Agenda
Village of Glen Ellyn
Special Village Board Workshop
Monday, September 9, 2024
6:00 PM
Glen Ellyn Civic Center, Room 301

Discussion of the Acceptance of the Public Improvements for the Main Street Garage

400 Apex Parking Facility Visual Review

April 14, 2023

Connection Type 87 from Mid-States Precast Drawing SP303

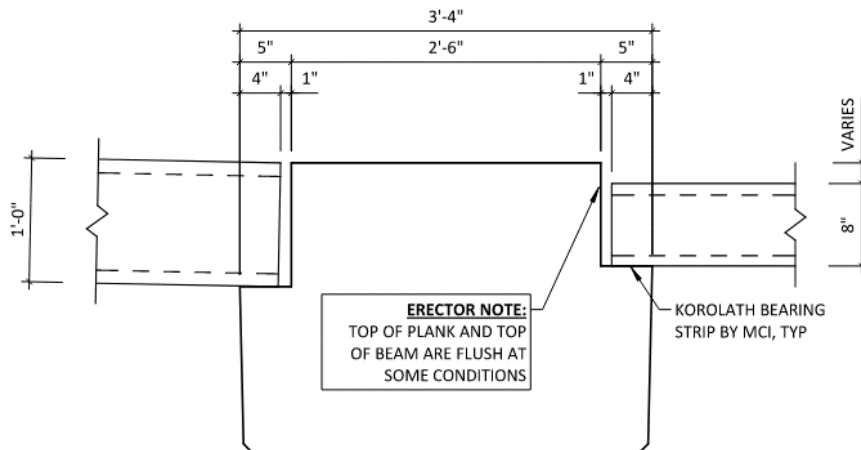
- b. Spall locations 1, 2, and 3 were specified to have Connection Type 87. We noted that this connection detail, shown below, does not include a steel dowel that was observed in the field. The steel dowels observed appear similar to the pins shown in Connection Type 103 above. The

connection detail also specifies a “Korolath Bearing Strip,” but we were unable to observe a bearing pad along the joint or within the spalled cavity from the ground. We noted the opposite end of the plank was specified to have Connection Type 110, which includes a welded fixed bearing.

Photo 10. Spall 5 along Grid 7.8 from Photo 8. Note, presence of dowel at center of spall. Also note an adjacent small spall. Presence of a bearing pad is not obvious from ground.

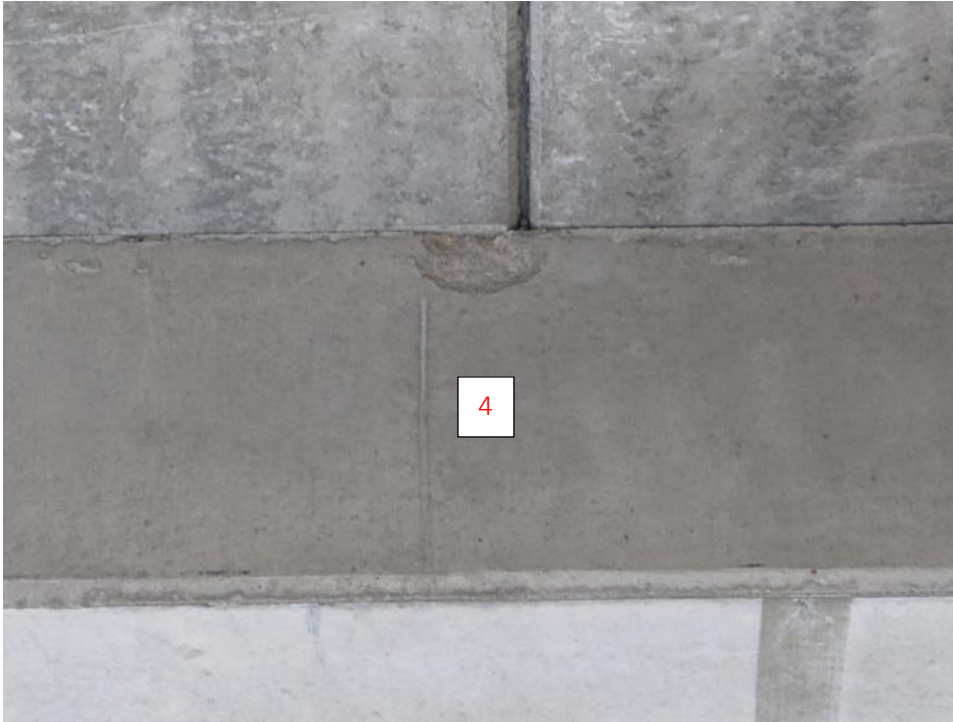
- e. Spalls 5, 6, and 7 along Grid Line 7.8, between Grids C and D. Concrete was reported to have fallen to the ground at this location in January 2023. The spalls were semicircular in shape. A steel dowel with adhesive appeared to be present at the center of each of the spalls with the spall radiating outward from the dowel. Some corrosion appeared to be present on the steel dowel. Adhesive surrounding the dowel was not obvious.

Photo 13. Spall 8 along Grid 7.8.

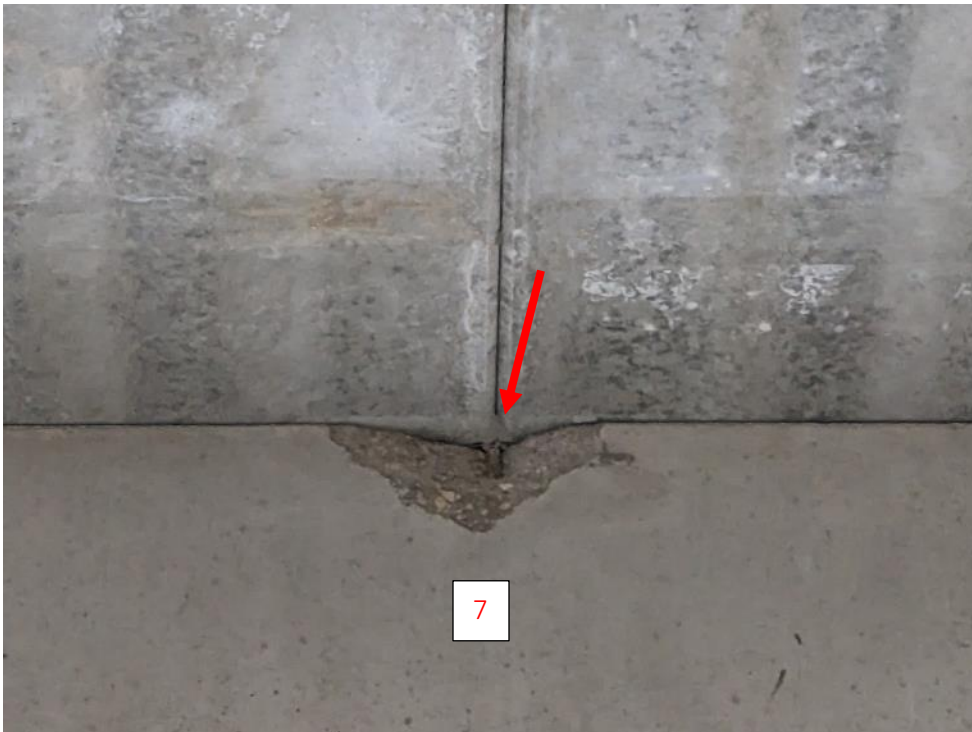
- f. Spall 8, along Grid Line 7.8, at Grid C. Concrete was reported to have fallen to the ground at this location in January 2023. The spall was semicircular in shape. A steel dowel with adhesive appeared to be present at the center of the spall and the spall radiating outward from the dowel.

A1 FIRST FLOOR PLAN
1/8" = 1'-0"

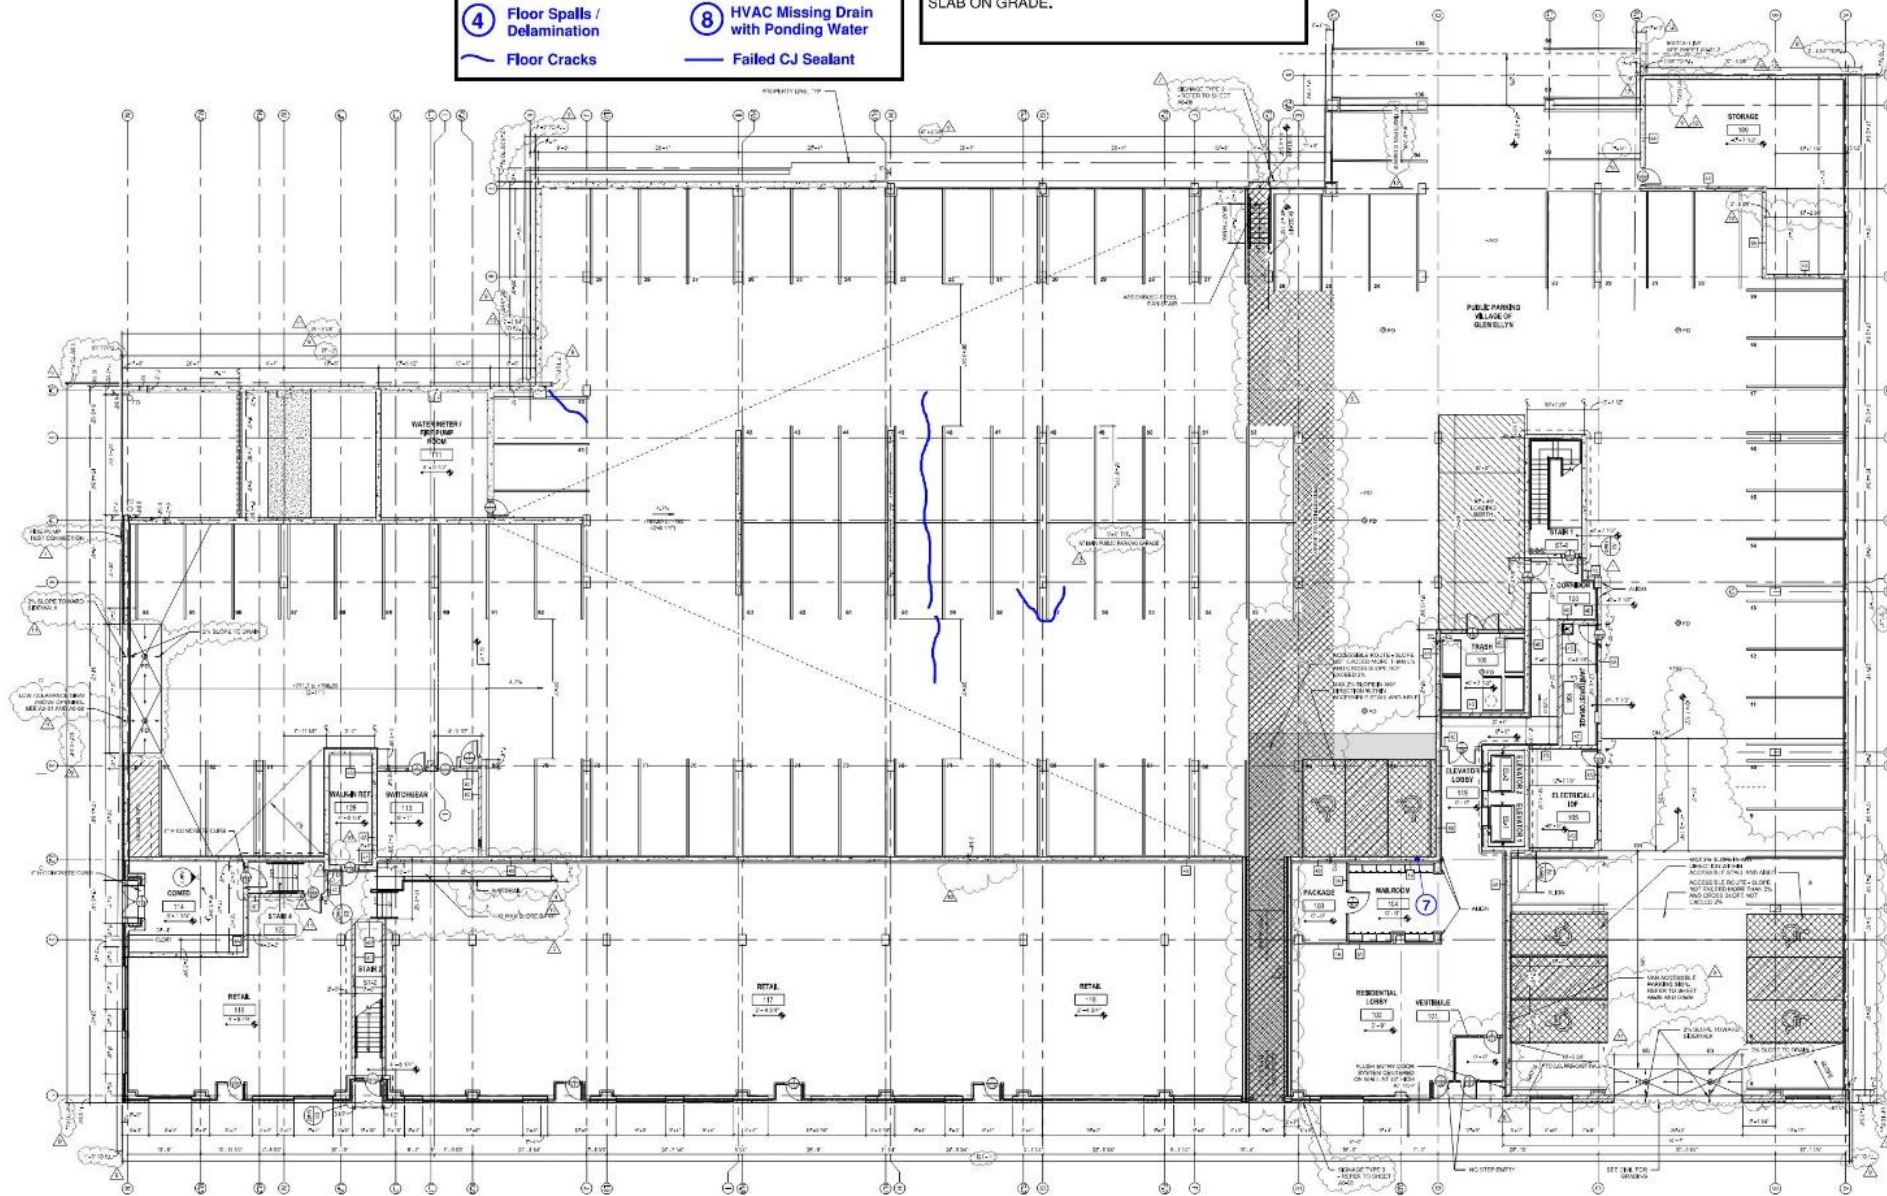
First Level Floors

1. Sealant was present in some of the slab-on-ground floor control joints in the south end but was typically not present in areas of the main section and finger slab-on-ground, as would often be required in a parking structure. (Photos 16 - 20).
2. Small concrete distress spalls were observed along a couple of slab-on-ground control joints in the finger area (Photos 19 and 20).
3. The slab-on-ground exhibited frequent random, narrow unsealed cracks (Photos 20 and 21).
4. At some finger column locations, the slab-on-ground included diamond shaped isolation control joints around the columns, while at locations along the south edge of the finger the control joints were not

present. Due to the lack of isolation control joints, narrow cracking frequently radiated from the column corners (Photo 23).

(A1) SECOND FLOOR PLAN
50' = 1" (NOT TO SCALE)

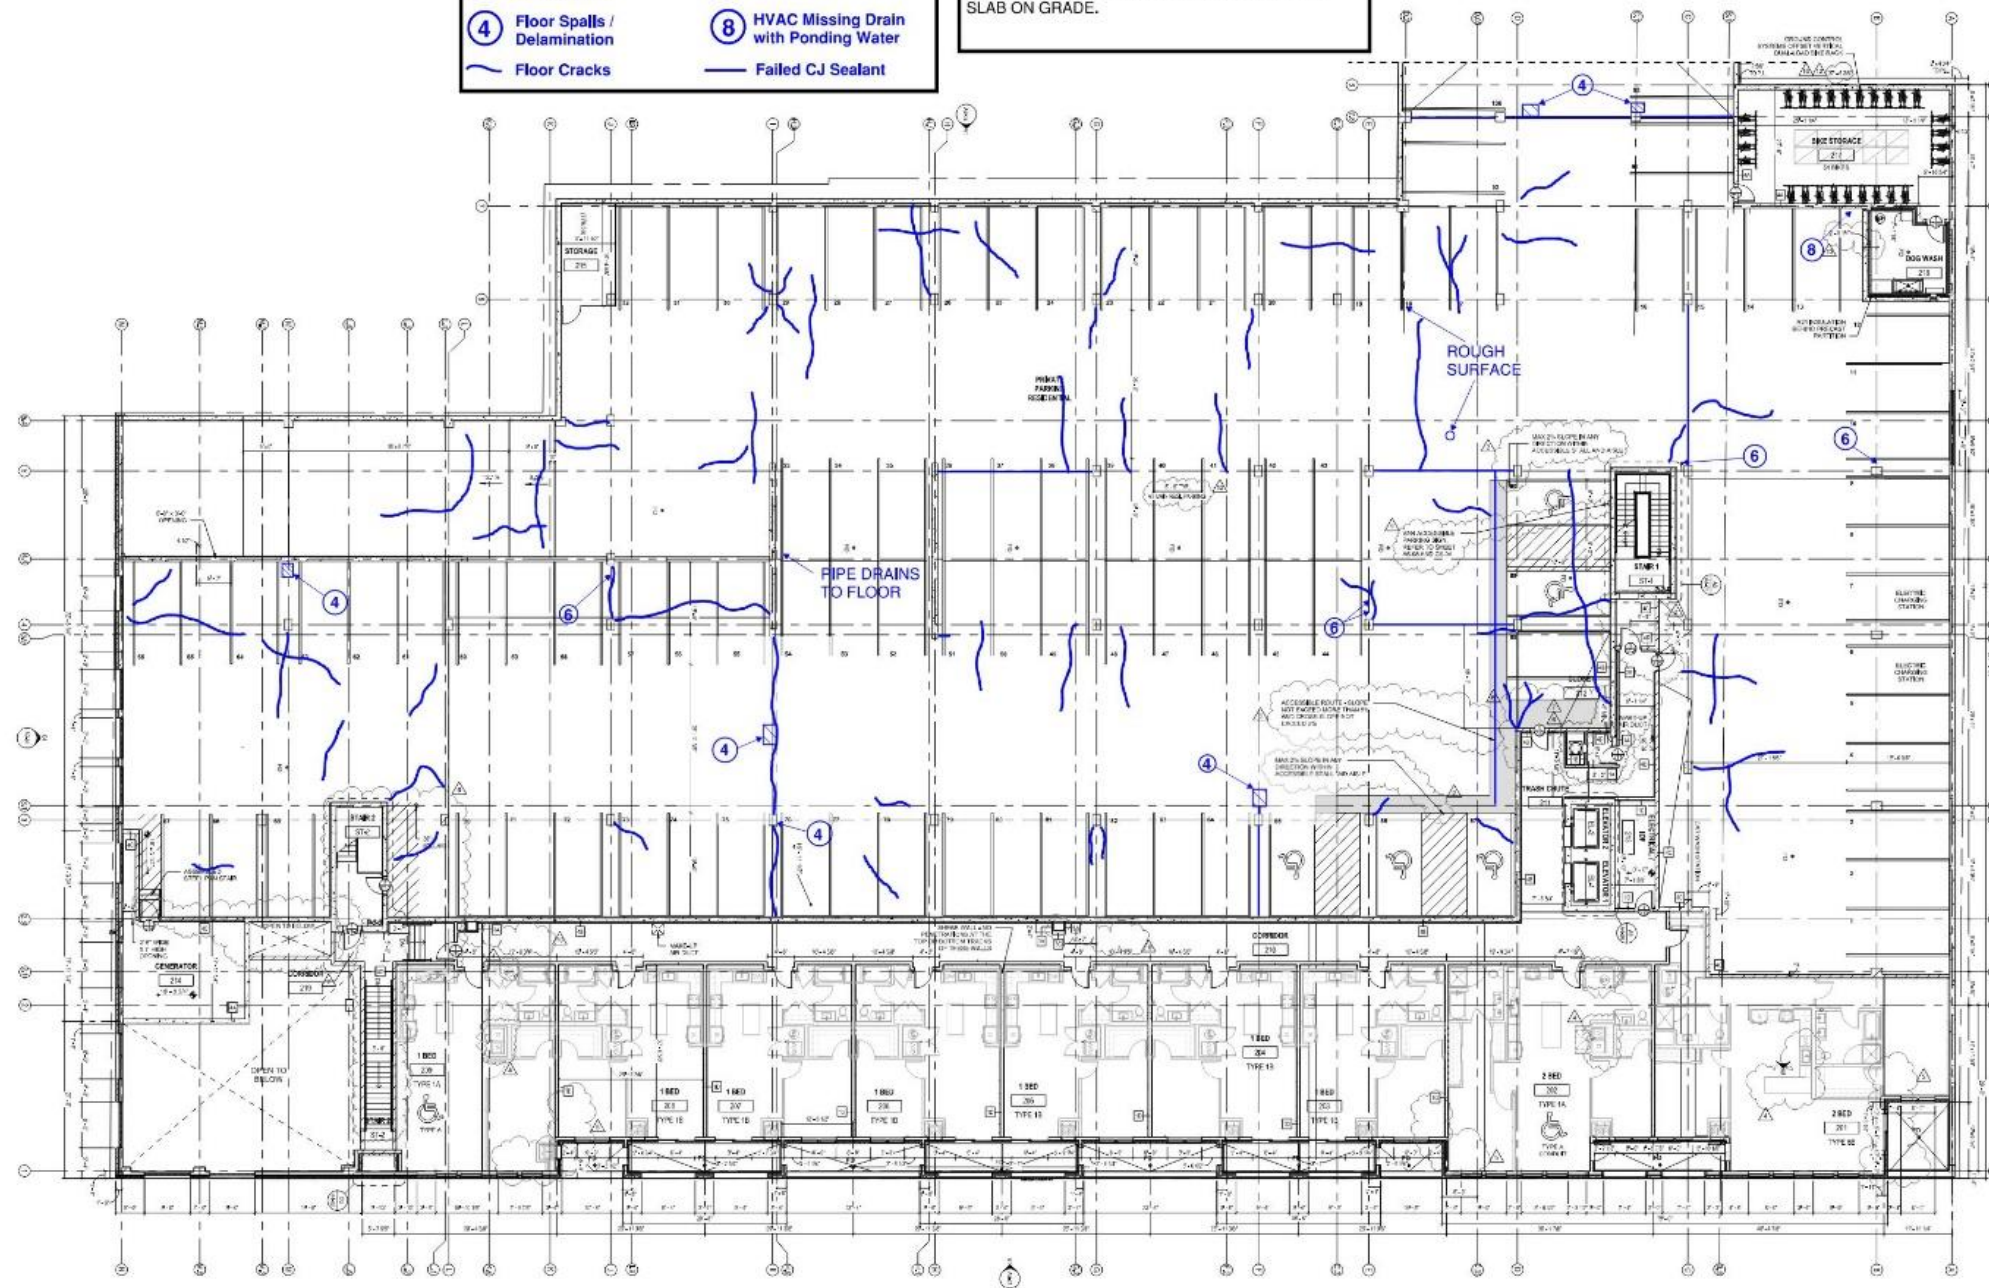
Second Level Floors

1. A few concrete cracks and delaminations were present in the floors at isolated locations (Photos 48 & 49).
2. We noted that the 2nd level topping slab did not have control joints at each hollow core slab joint, as is frequently used in parking structures, but incorporated a nominal 15'x15' control joint pattern.
3. Floor cracks in the concrete topping were common throughout the 2nd level floor and may allow water penetration (Photos 50 to 56). The cracks varied in size from hairline to over ¼" at one location. The

floor cracks were often observed parallel to the hollow core plank joints where control joints were omitted and at some locations perpendicular to the hollow core. Cracks were also noted to radiate from some wall corners and through pipe penetrations.

4. Prematurely failed control joint sealant was frequent throughout the 2nd level (Photos 58 to 61).
5. Cove sealants were present at the wall-to-floor interface at some locations, typically near the south end, but were missing at many locations resulting in an open joint that can allow for water penetration through the floor slab (Photo 62). Additionally, unsealed joints were typically present at the shear walls (Photo 63) and columns (Photo 64).
6. The perimeter around pipe penetrations through the floor were typically unsealed and can allow water penetration through the floor slab (Photos 65 and 66).
7. The finger floor was not visually surveyed due to snow and ice covering the surface at the time of the visit.
